SUPPLEMENTAL
SAFETY EVALUATION REPORT

RELATED TO
RENEWAL OF THE
OPERATING LICENSE
FOR THE
RESEARCH REACTOR
AT THE
UNIVERSITY OF CALIFORNIA AT LOS ANGELES

DOCKET NO. 50-142

DATE: OCTOBER 1982

FIGURE 11-4-1

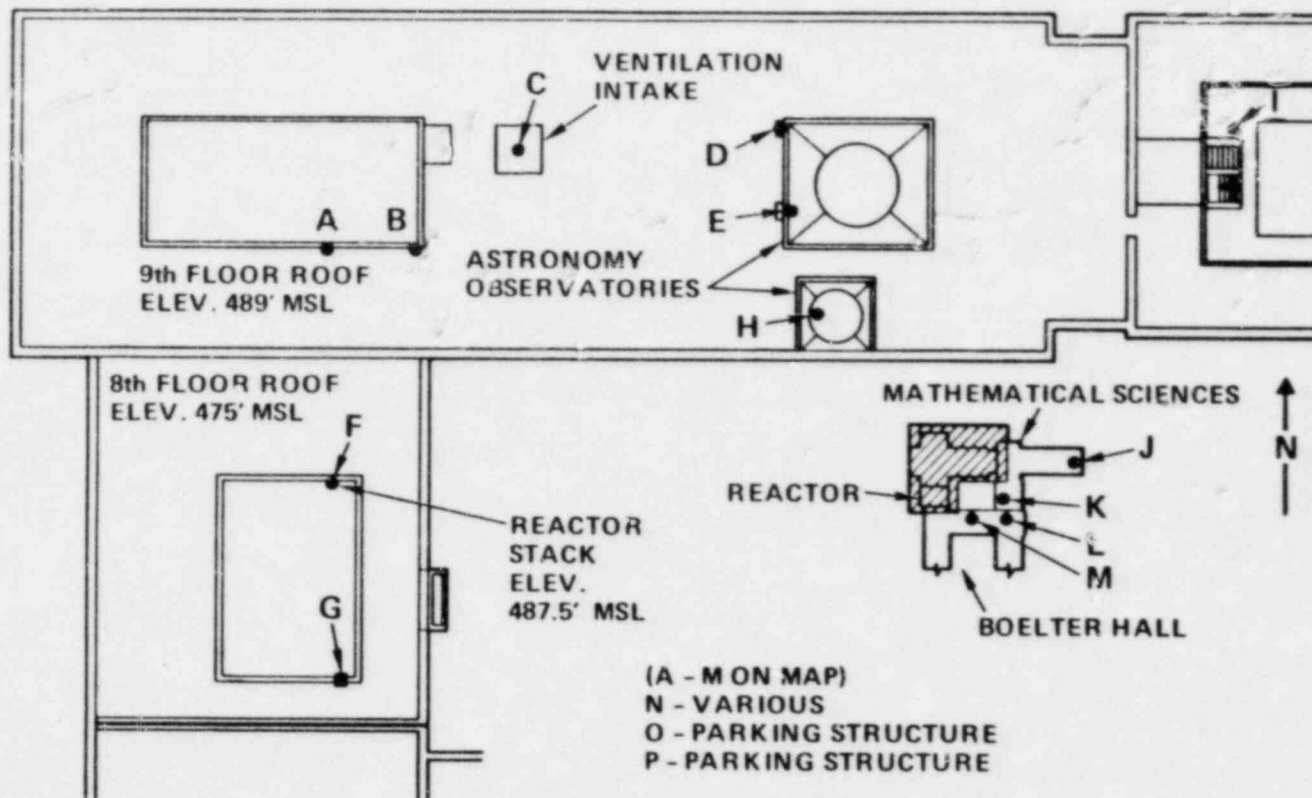
The new environmental survey utilized 16 TLD's, the locations of which were consistent with the Nuclear Energy Laboratory (NEL) discharge stack, local meteorology, and the Math/Science Building ventilation intake. Locations are shown in Fig. 11-4-1. Some of the TLD's were fitted with lead bricks for shielding against natural radiation emissions from the adjacent concrete structure; others were placed on the structure itself if natural radiation were of no concern.

The TLD readings are shown in Table 11-4-2. TLD "F", which was located in the exhaust fan inlet plenum chamber, can be considered analogous to TLD No. 3 of the 1976-78 series which had been placed on a screen across the mouth of the Nuclear Engineering Laboratory discharge stack.

TLD "F" read 48-52 mrem for about 348 days of exposure and 24 MW hrs. of operation. In the 1976-1978 survey, TLD No. 3 read 44 mrem for 20 MW hrs. of operation and 1 year of exposure. If these values are normalized for 44.2 MW-hrs, the maximum annual MW-hours of operation permitted in the Technical Specifications, the respective TLD values would be approximately 88.4-95.7 for TLD "F" and 95 for TLD No. 3. The values of the two different surveys when normalized are similar. Each of these values are less than 2% of the values given in 10 CFR §20.101 for restricted areas.

The supplemental information provided in amended Appendix II corroborates the analyses in the SER derived from values in the 1980 submittal. Accordingly, the conclusions in the SER, which indicate that Ar-41 discharges from NEL are a fraction of 10 CFR §20, still pertain.

Fig. 13-3-1 Reactor Organization: Normal, Emergency, and Extensions
 (extensions removed for this report)

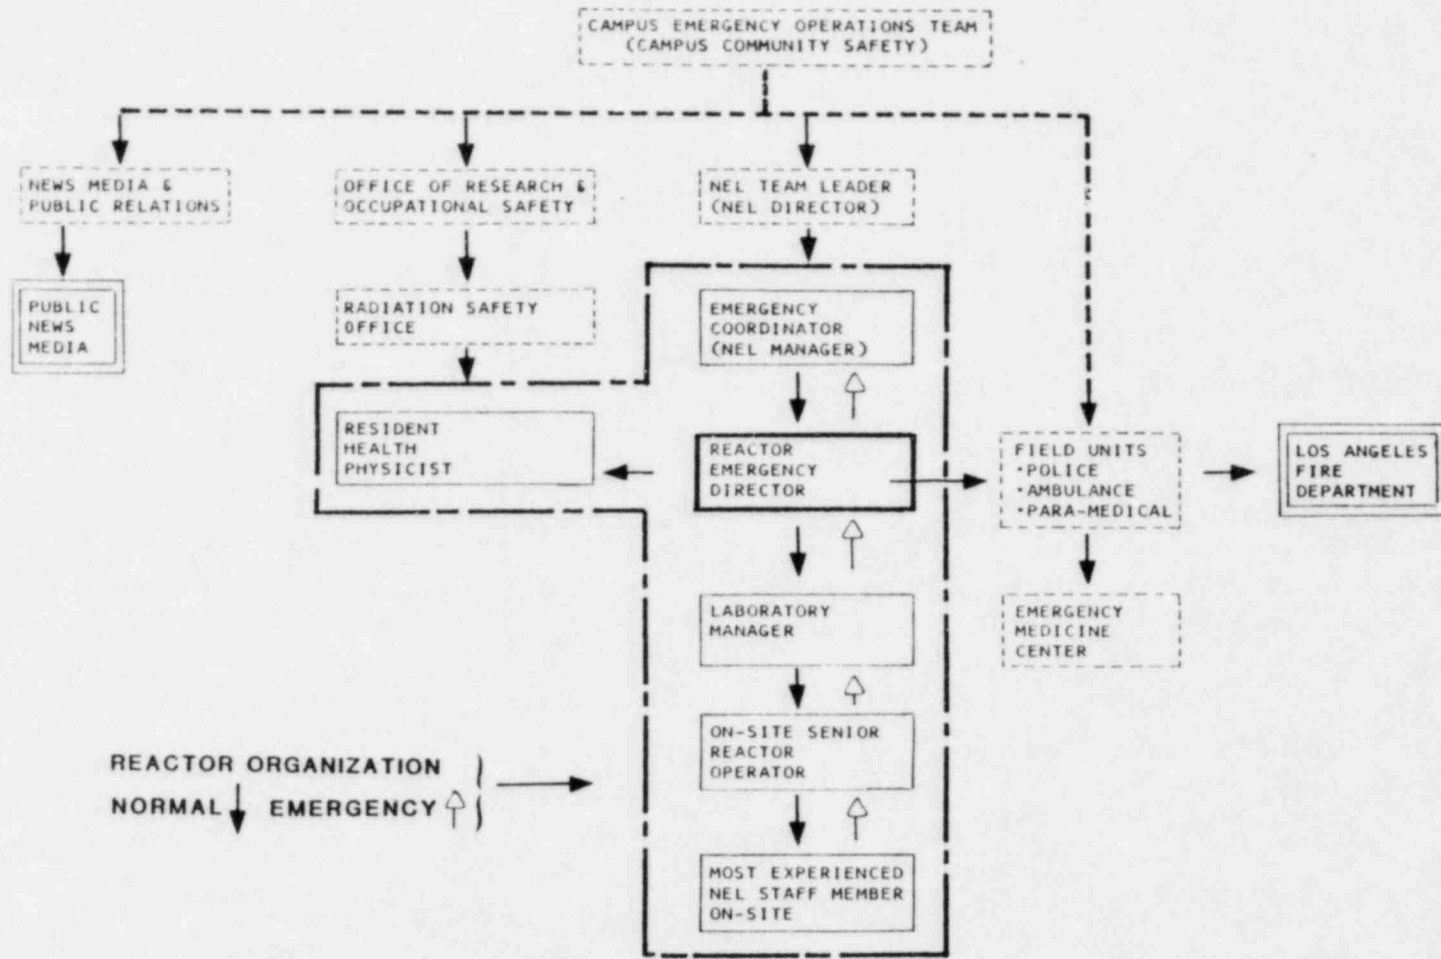
A block diagram (Fig. 13-3-1) shows the relationships and interfaces among the components of the overall (reactor, campus, offsite) emergency response organization. A copy of the Letter of Agreement with the off-site support agency is included in the Plan.

The intent of the planning standard has been addressed and we conclude that this portion of the Plan is adequate.
